UNITED STATES PATENT AND TRADEMARK OFFICE

APPLICATION NO.	FILING DATE	FIRST NAMED INVENTOR	ATTORNEY DOCKET NO.	CONFIRMATION NO.
10/625,643	07/24/2003	Shinichiro Fujita	116668	9724

Office Action Summary

DETAILED ACTION

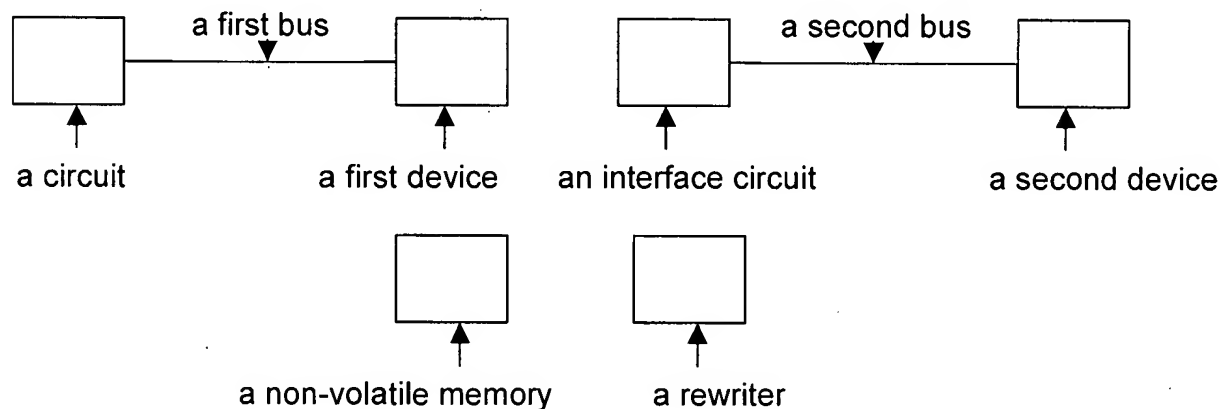
The Examiner would like to illustrate, in the form of the picture shown *infra*, how the Examiner is interpreting the instant claim language insofar as it appears to be clear:

As amended, independent claim 1 recites, 'the rewriter loading and writing information transferred from the first device through the first bus into a rewrite area of the non-volatile memory when the rewriter is activated by the rewriter activation section.' This is indefinite. As shown *supra*, the non-volatile memory is not connected or coupled to anything. The Examiner is unsure how information can be transferred from the first device through the first bus **into a rewrite area of the non-volatile memory** when there appears to be no positive recitations of connections or couplings to the non-volatile memory.

Further, as amended, independent claim 1 recites, 'when the second bus is detected to have a connection to the second device, the circuit performing packet transfer through the first bus conforming to a first interface standard...' This is indefinite. As shown *supra*, there appears to be no positive recitation of a connection or coupling that would allow the circuit to discover that the second bus is connected to a second device. Therefore, the Examiner is unsure how the circuit can begin packet transfer without such connection or coupling.

Additionally, independent claim 1 recites, 'the rewriter activation section activating the rewriter to start processing when the second bus is detected to have no connection to **any device**' (emphasis added). This is indefinite. If the second bus is not connected to **any device**, how can the rewriter (broadly interpreted as a device) start processing if it is not connected to discover such disconnect or total lack of connection thereof?
